Subject: Notification of Class 1 Permit Modifications to Hazardous Waste Facility Permit and Notice of Changes to the Hazardous Waste Facility Permit Contingency Plan, Permit Number: NM4890139088-TSDF

**Notice of Contingency Plan Changes
in Accordance with 20 NMAC 4.1.500
(40 CFR Part 264)**

**Waste Isolation Pilot Plant
Carlsbad, New Mexico**

**Notice of RCRA Permit Modification
in Accordance with 20 NMAC 4.1.900
(40 CFR Part 270)**

Figure F-1
WIPP Surface Structures

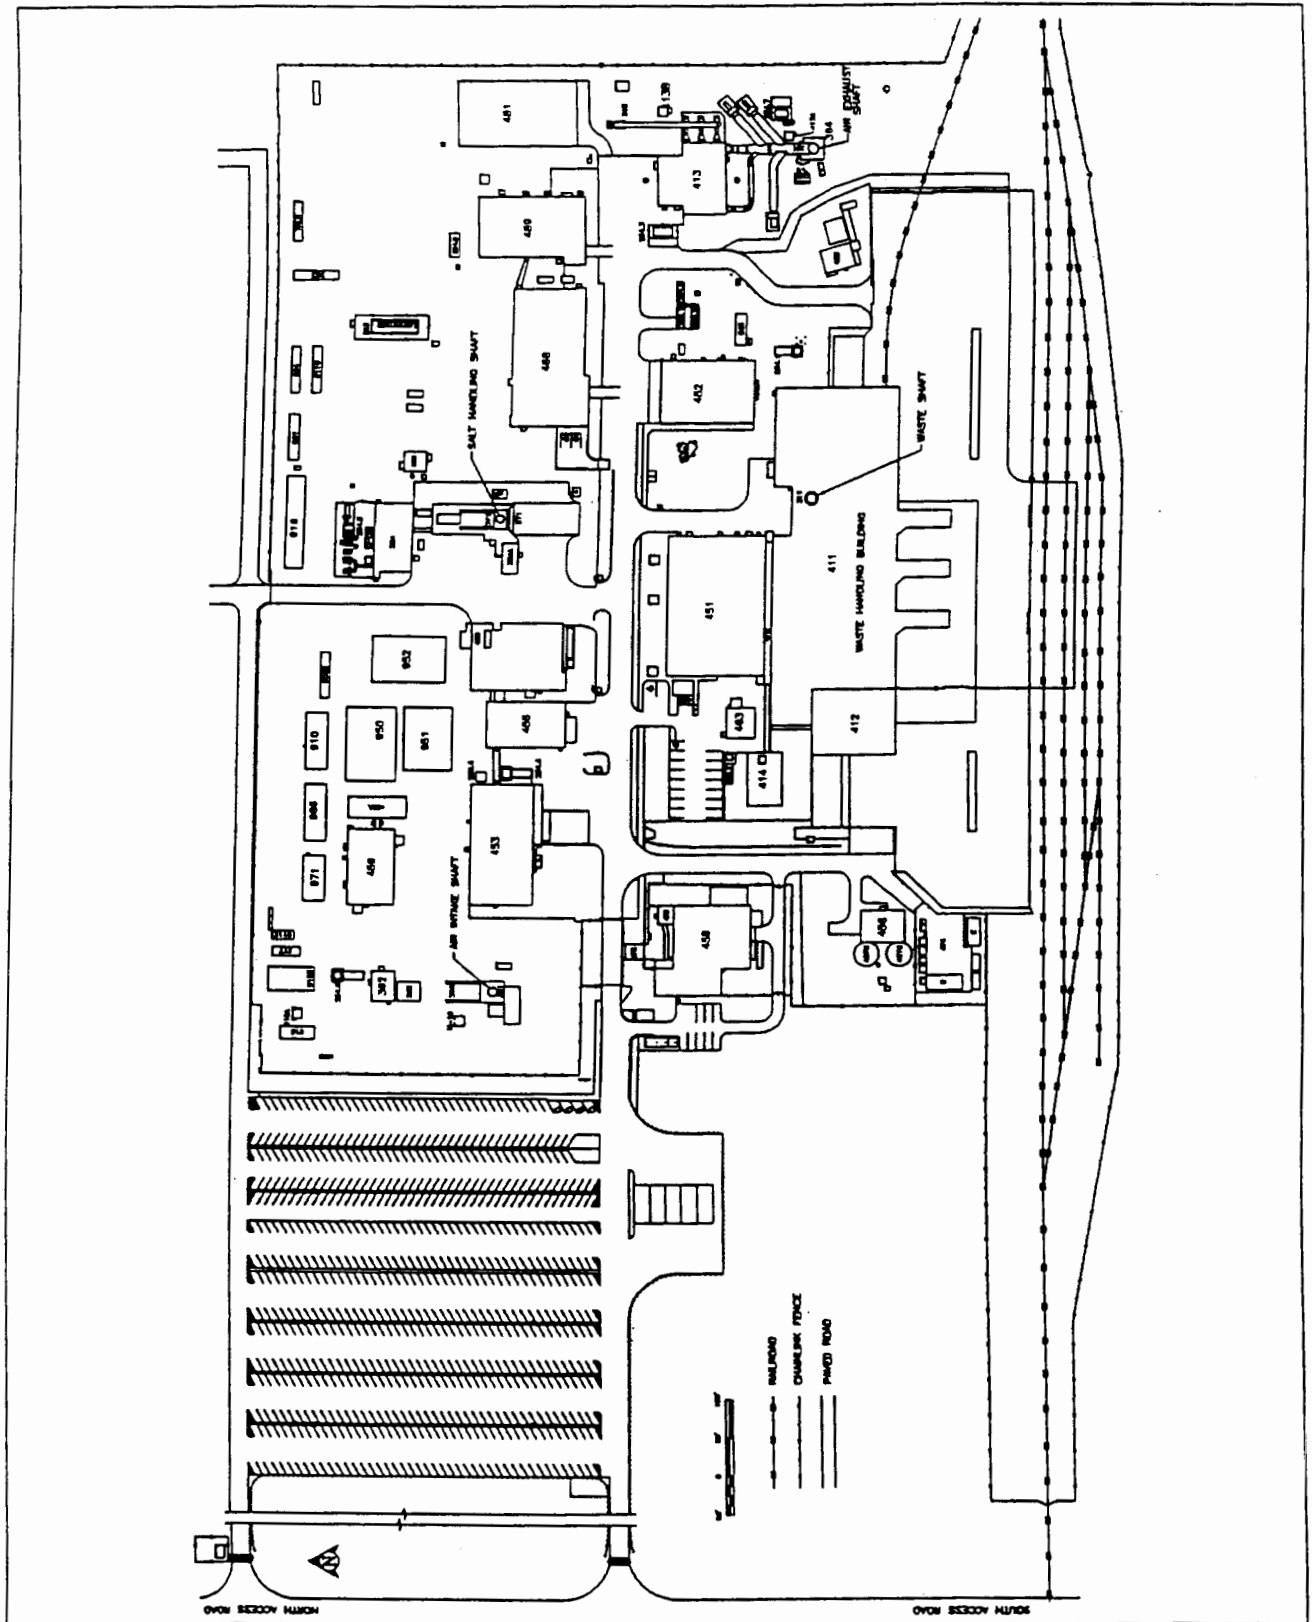
Figure F-1 WIPP Surface Structures

These figures were changed as a result of the fact that certain, non-essential, trailers were removed from the site. As such, it is no longer necessary to show them on the figures.

Figure F-6
Fire-Water Distribution System

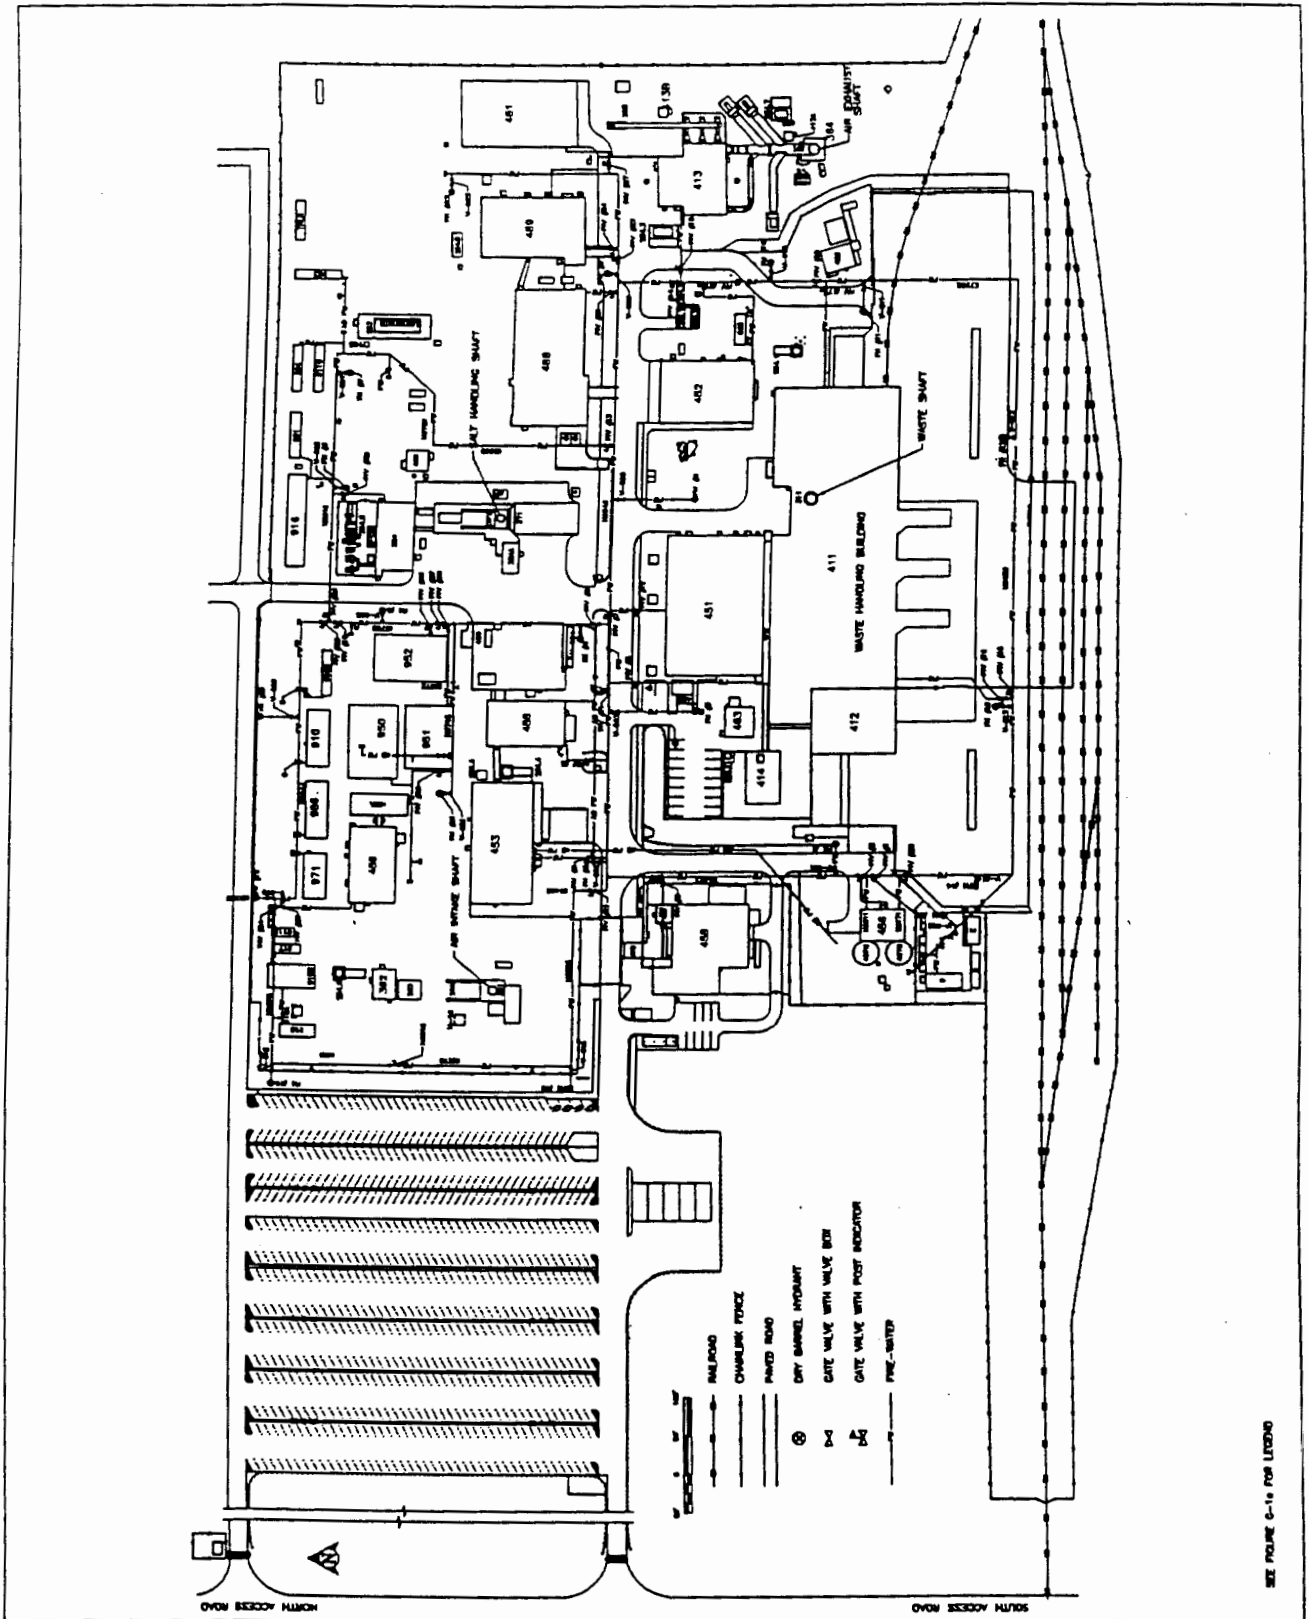
Figure F-6 Firewater Distribution System

Figure F-8
WIPP On-Site Assembly Areas and WIPP Staging Areas

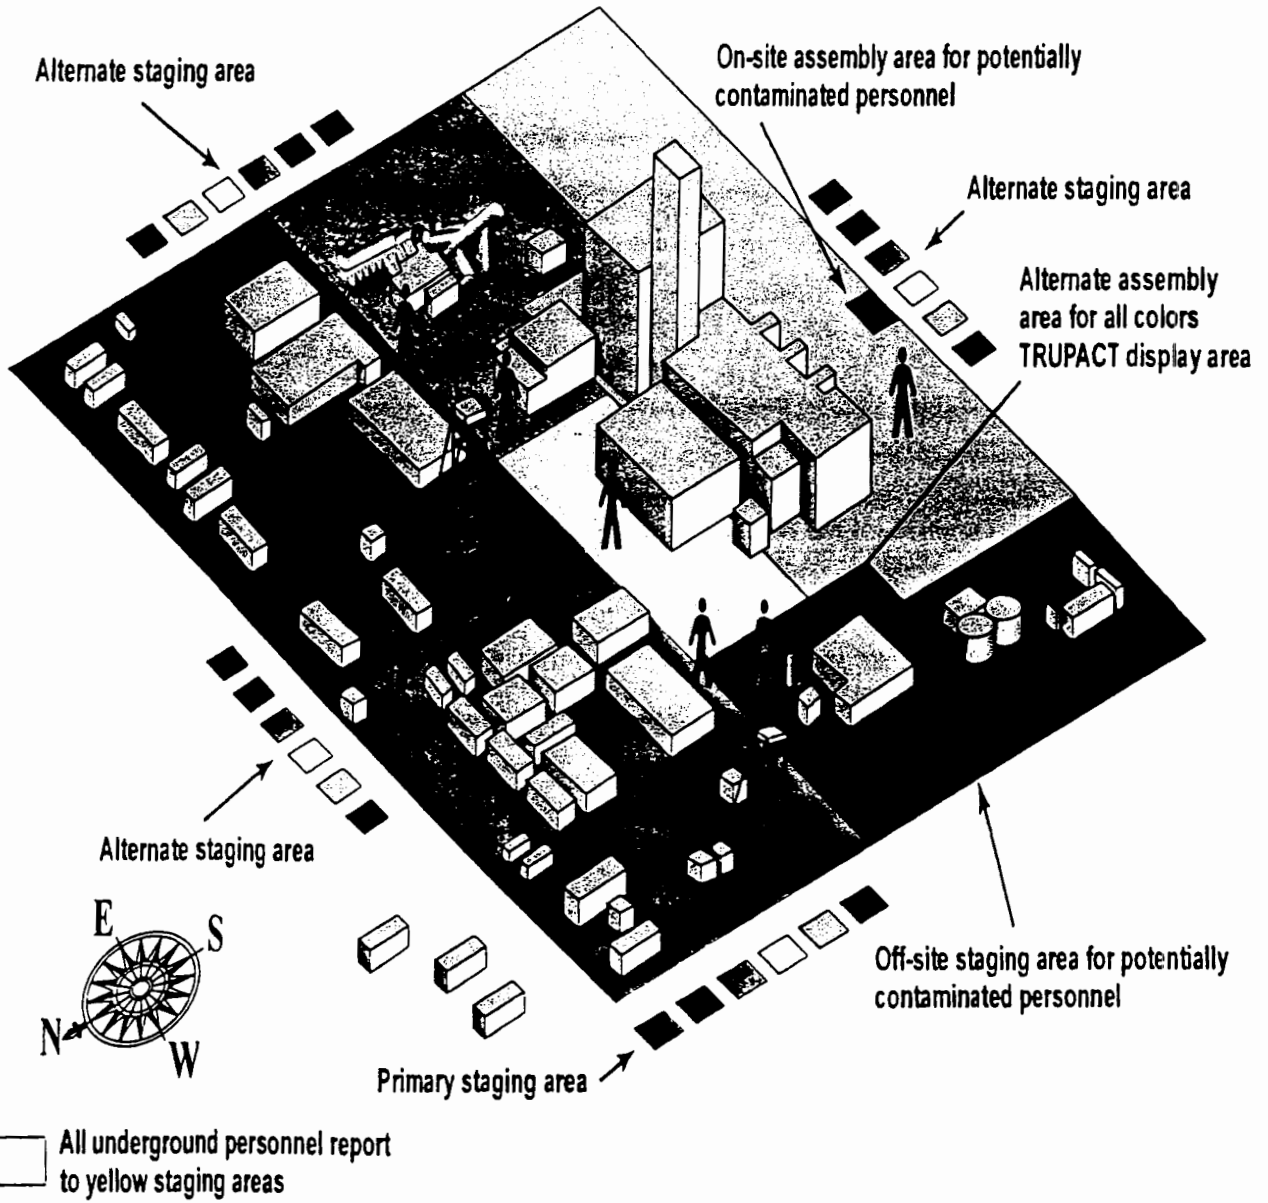
Figure F-8 WIPP On-Site Assembly Areas and WIPP Staging Areas

Figure F-10. Waste Handling Building Pre-Fire Survey (First Floor)

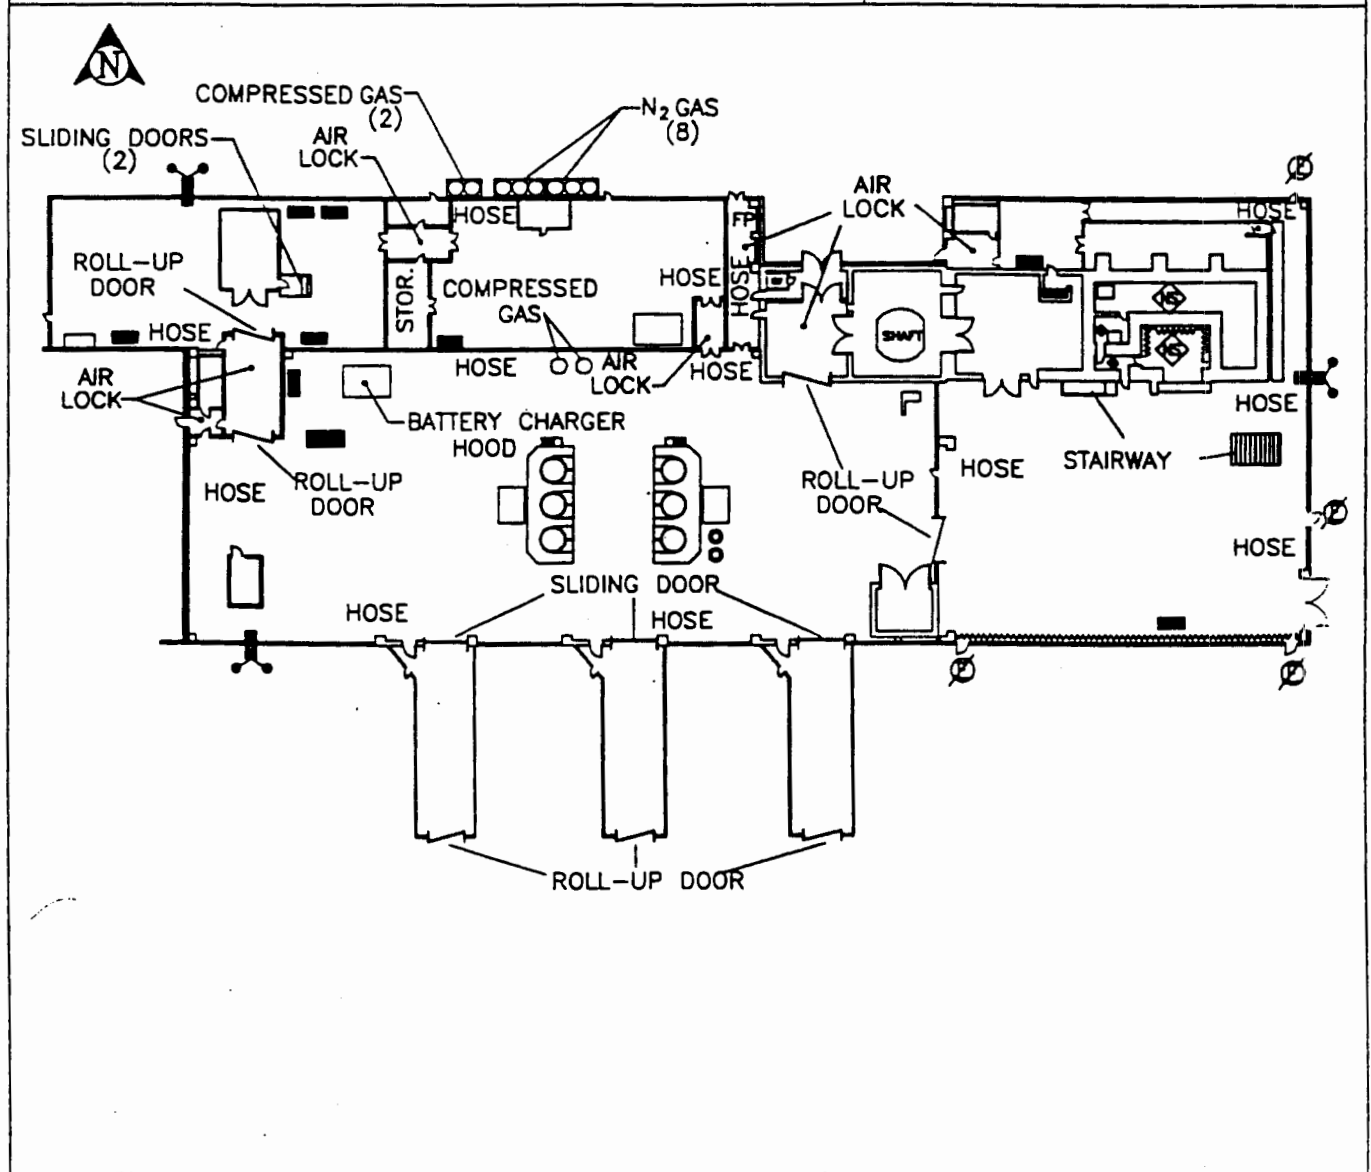
Figure F-10 Waste Handling Building Pre-Fire Survey (First Floor) has been revised and Figure 10a Waste Handling Building Pre-Fire Survey (First Floor - Fire Hydrant/Post Indicator Location) has been added.

Revised figures more accurately reflect the current configuration of the site and provide more detail with regard to the location of fire hydrants and post indicator valves.

Figure F-11a. Waste Handling Building Pre-Fire Survey
(Second Floor - Fire Hydrant/Post Indicator Location)

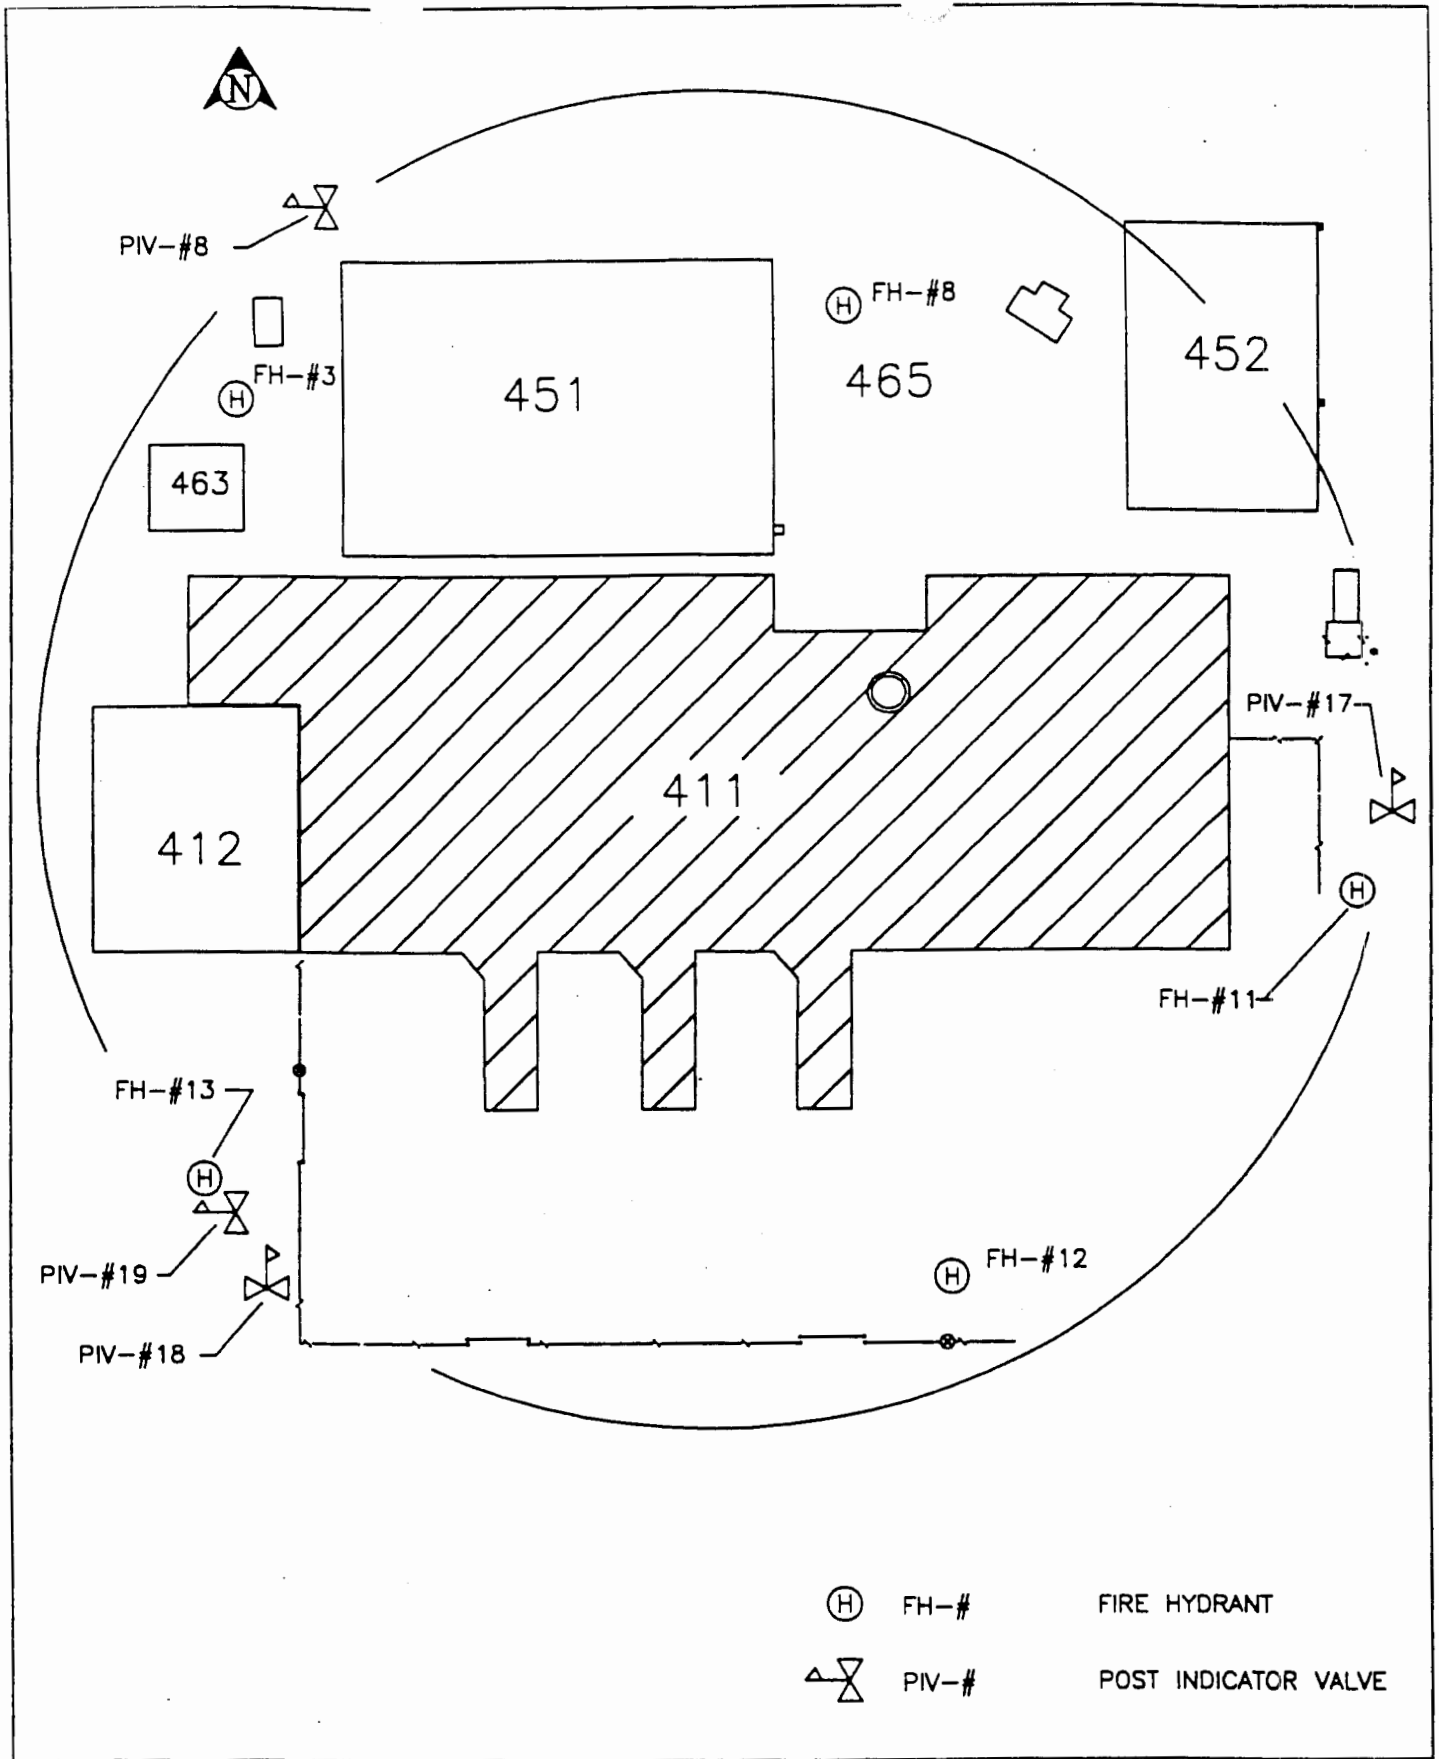
Figure F-11 Waste Handling Building Pre-Fire Survey (Second Floor) has been revised and Figure 11a Waste Handling Building Pre-Fire Survey (Second Floor - Fire Hydrant/Post Indicator Location) has been added.
